Comments on Draft 2.1

**IEEE P803.2an Task Force
San Francisco, July '05**

PBO/THP Increase Transition

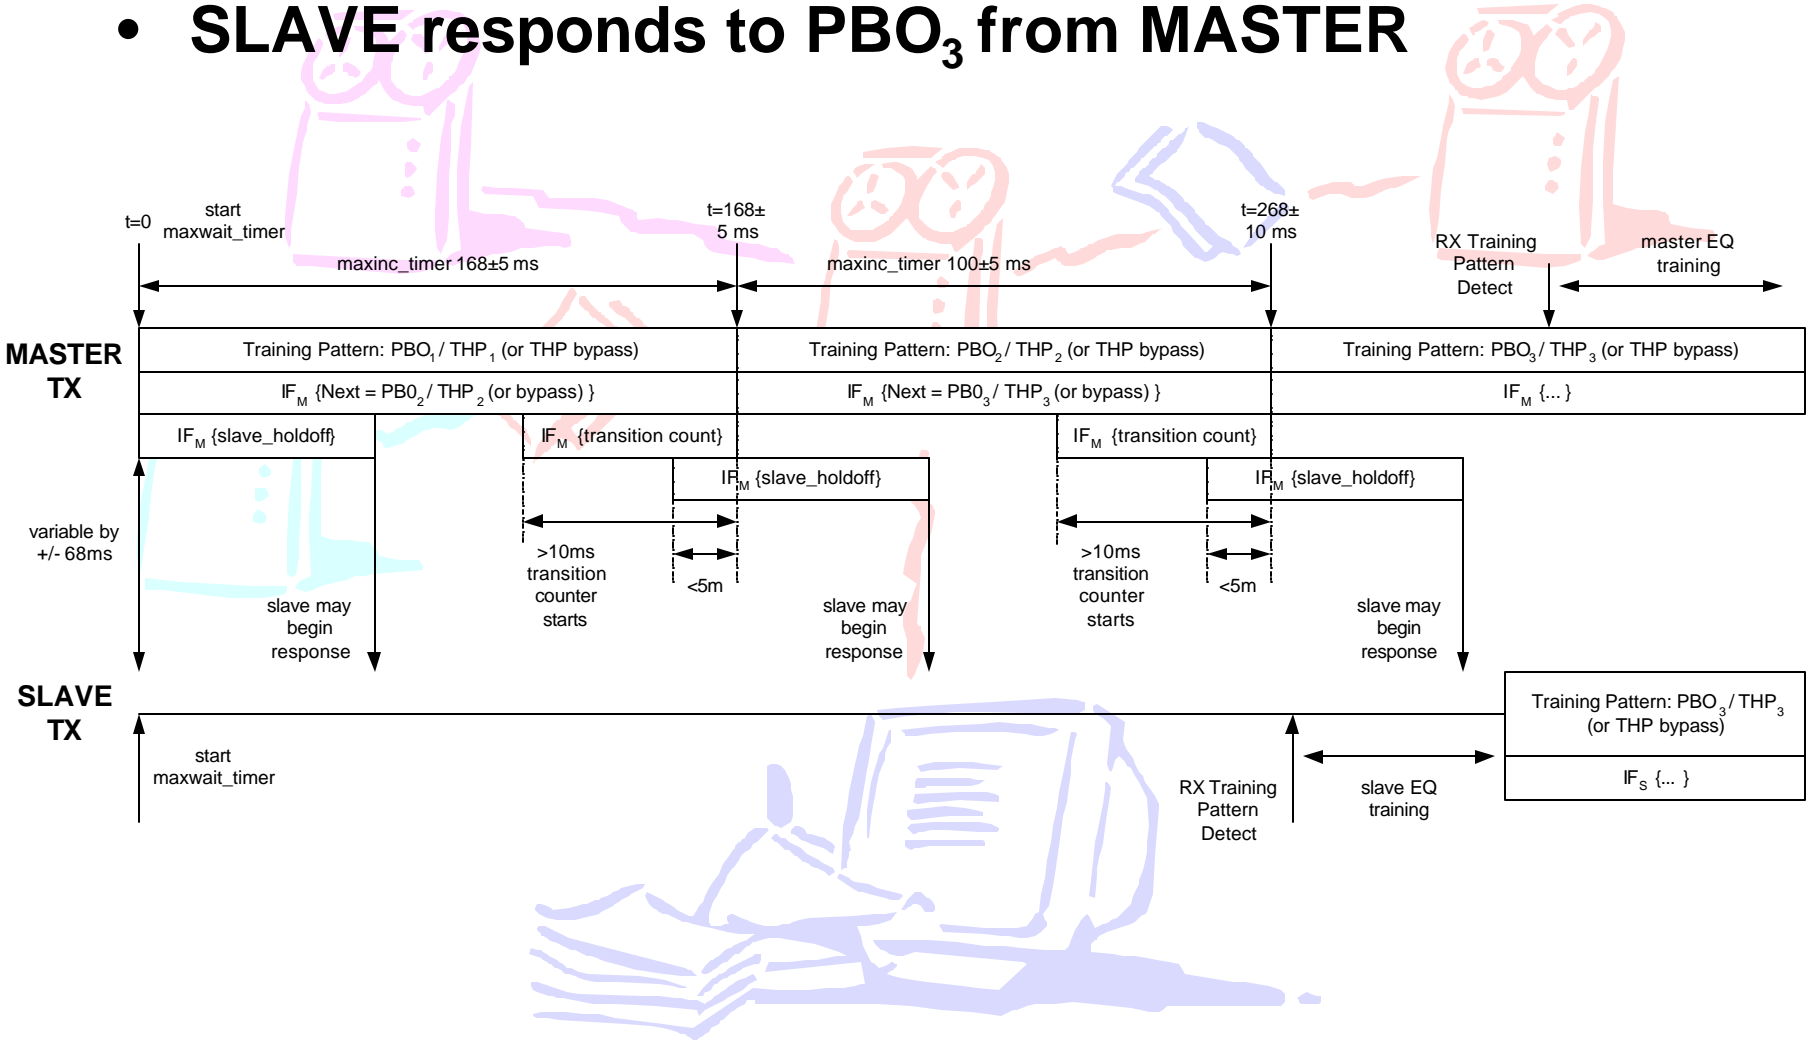
- 55.4.5.1 page 112 line 16
 - "transition_count" lacks a description of the transition for PBO/THP_increase.
 - Suggested text:
 - In the PMA_Training_Init_M state, the MASTER initiates the transition count for a PBO/THP increase with "PBO/THP_increase" flag and a minimum counter value of 2^9 (~10ms) and maximum of $2^{12} - 1$. The SLAVE will respond prior to the counter reaching 2^8 (~5ms) else it holds off until the next PBO/THP setting from the master. Upon detection of the SLAVE's training pattern and if the transition count is greater than 2^6 (~1ms) the MASTER will abort the transition, reset the PBO/THP_increase flag and set the Next transmitter setting octet to the current PBO and THP settings.

Long Line Case

- **SLAVE responds to PBO₃ from MASTER**

Very Short Line

- **SLAVE responds to PBO₁ from MASTER**

- change:
 - The MASTER initiates the transition count with "trans_to_Training_Update" flag and a minimum counter value of 2^9 (10ms) and maximum of $2^{12} - 1$.

- to: The MASTER initiates the transition to PMA_Training_Update count with the "trans_to_Training_Update" flag and a minimum counter value of 2^9 (10ms) and maximum of $2^{12} - 1$.
